Appliance Standards Awareness Project
American Council for an Energy-Efficient Economy
Alliance to Save Energy
Natural Resources Defense Council
Northwest Energy Efficiency Alliance
Northwest Power and Conservation Council

November 12, 2013

RE: Docket Number EERE–2010–BT–STD–0003/ RIN 1904–AC19: Notice of Proposed Rulemaking for Commercial Refrigeration Equipment

Figure 1. VCS.SC.L Models in ENERGY STAR QPL Compared to the Current Standard, the NOPR “Baseline,” and TSL 4.

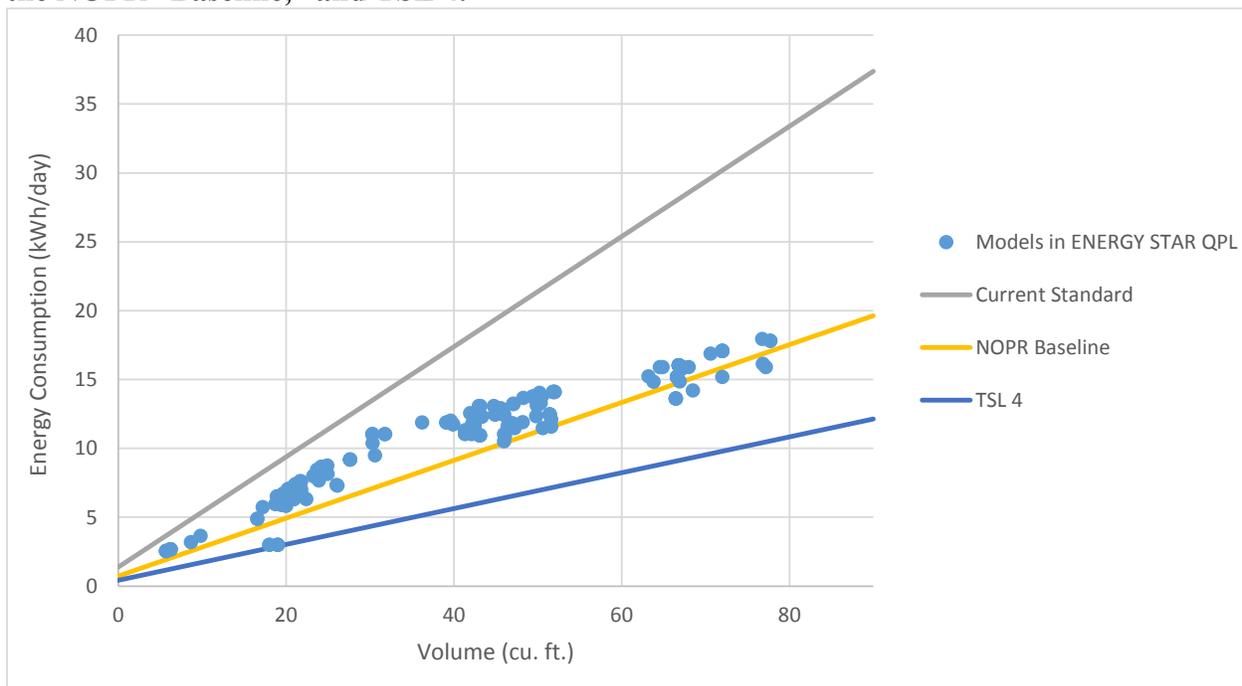
We encourage DOE to re-evaluate the baseline levels for the equipment classes for which the current standards were established by EPACT 2005. For seven of the self-contained,

closed-door equipment classes for which the current standards were established by EPACT 2005 (VCS.SC.M, VCS.SC.L, VCT.SC.L, HCS.SC.M, HCS.SC.L, HCT.SC.M, HCT.SC.L), the “baseline” levels assumed in the NOPR are significantly more stringent than the current standards. We understand that the “baseline” levels are intended to reflect the energy consumption of the least-efficient models that are currently available. Data from the ENERGY STAR QPL indicate that for at least some of these seven equipment classes, many of the ENERGY STAR-qualified products have energy consumption levels that are higher than the “baseline” levels in the NOPR. Figures 1 and 2 below show the models in the ENERGY STAR QPL for self-contained, solid-door vertical freezers (VCS.SC.L), and self-contained, solid-door horizontal refrigerators (HCS.SC.M), respectively, along with the current standards, the “baseline” levels assumed in the NOPR, and the proposed standards (TSL 4).¹⁶ For these two equipment classes, the majority of the ENERGY STAR-qualified products have energy consumption levels higher than the “baseline” levels in the NOPR, and in the case of the HCS.SC.M class, there are ENERGY STAR-qualified products with energy consumption levels more than twice as high as the “baseline” levels.

Figure 3. DOE Price Projections of LED Lamps (\$/klm) in the 2010 MYPP (left) and the 2013 MYPP (right).²¹

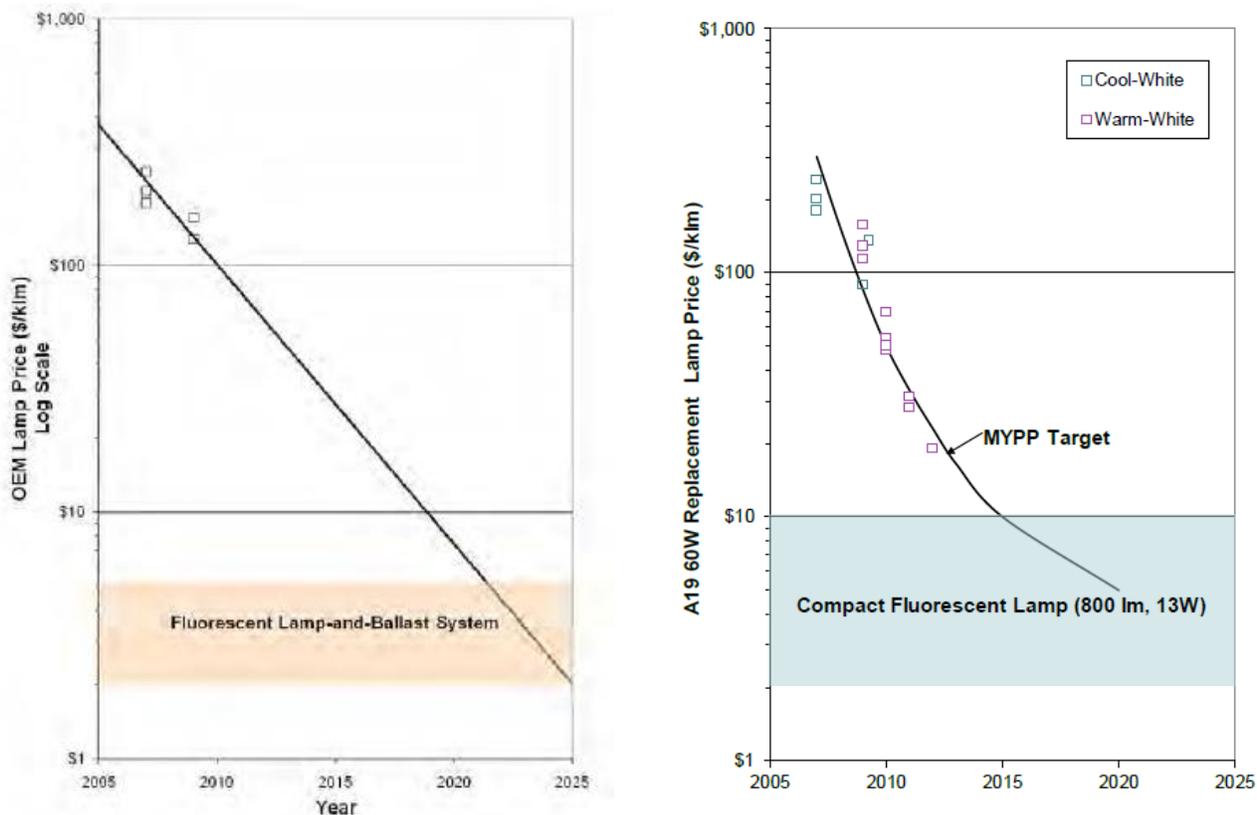
We strongly support the incorporation of LED price projections. In the analysis for the NOPR, DOE incorporated price projections from its Solid-State Lighting Program into the estimates of manufacturing production cost (MPC) for the representative units.¹⁷ DOE shows in the NOPR that LED prices are projected to decrease by more than a factor of 5 between 2010 and 2017, and are projected to decrease by almost another factor of 5 between 2017 and 2030.¹⁸ The incorporation of LED price projections significantly improves the analysis by better reflecting a realistic estimate of LED costs.

As part of the Solid-State Lighting Program, DOE has tracked both the prices of LED luminaires and how they compare to the Multi-Year Program Plan (MYPP) projections of LED luminaire prices. Figure 3 below shows DOE’s price projections in the 2010 MYPP (left) and the 2013 MYPP (right). As can be seen in Figure 3, prices have dropped at a faster rate than DOE’s 2010 MYPP projected. In the 2011 MYPP, DOE updated the MYPP price targets due to this rapid decrease in prices—DOE found that normalized prices in 2010 had dropped to about \$50/klm some two years ahead of the original schedule.¹⁹ In the 2013 MYPP, DOE noted that 2012 prices of about \$19/klm are slightly ahead of the MYPP projection (as can be seen in Figure 3).²⁰ These data suggest that DOE’s price projections for LED lamps have actually been somewhat conservative.
